**SCHWEIZER
SERVICE
LETTER**

LETTER NO. L-63
DATE Nov. 1, 1971
PAGE 1 OF 1

SUBJECT: LYCOMING SERVICE BULLETIN NOS. 340 AND 341,
DATED AUGUST 27, 1971

MODELS AFFECTED: All 269 Series Helicopters

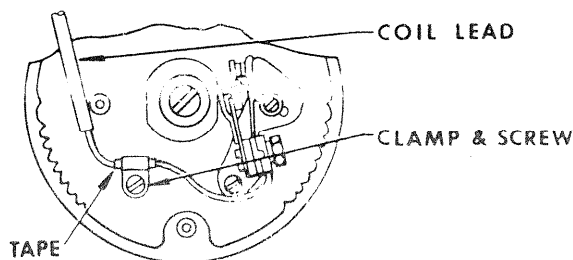
REASON FOR BULLETIN: To Inform Operators of the Availability of Securing Clamp No. 10-5752 for the Coil to Breaker Primary Lead in Single Breaker Magnetos.

Detailed Instructions:
Service experience indicates it is desirable to secure the coil to breaker primary lead in single breaker left hand rotation S-1200 Magnetos with a clamp as shown in sketch. Two different diameter primary leads have been used on the S-1200 series coils. For the smaller diameter lead it is recommended that a 1 inch piece of

3/4 inch wide tape be wrapped around the lead to provide secure clamping.

- 1. Clamp 10-5752
- 1. Screw 10-35936-7
- * 1 inch of 3/4 inch wide #32 Scotch Tape

Figure 1.
S-1200 Distributor Gear Detail

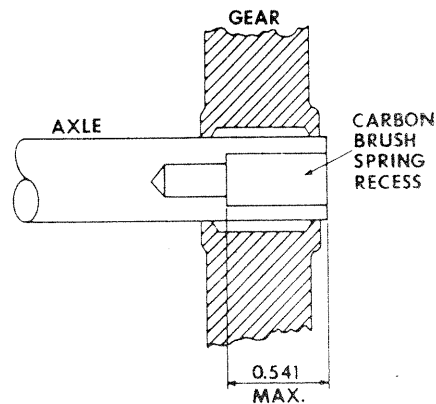
Field reports indicate that some S-1200 magnetos presently in service have the locating shoulder for the carbon brush spring in the large distributor gear incorrectly positioned. This shoulder is either missing or is located deeper than the 0.541 inch maximum spring recess depth illustrated in figure 1.

Improper shoulder location allows the carbon brush to move too far within the axle, thus reducing brush tension against the coil tab and under certain conditions produces arc erosion on the tab face. Operational effect on magneto output is inconsequential, however it is recommended that any gear found with the shoulder out of dimension be removed from service.

Reject any gear assembly which has a shoulder incorrectly located. Repair any coil tab showing arc erosion following the procedure described in Bendix Service Bulletin No. 526B.

Figure 2.
Suggested Tool for Checking Carbon Brush Spring Recess Dimension

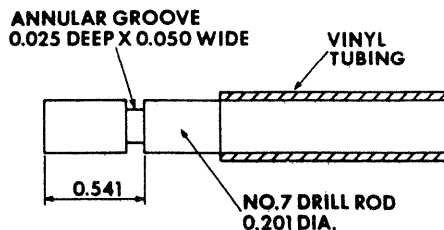
Shoulder location can be checked with Verniers or with a suggested tool which can be locally fabricated as illustrated in figure 2.

To check shoulder location, remove the carbon brush spring assembly, insert Verniers and measure for shoulder location or use the suggested tool. The 0.541 edge of the annular groove of the tool shall not disappear from view within the axle spring recess. Spare gear assemblies must be checked in a similar manner.
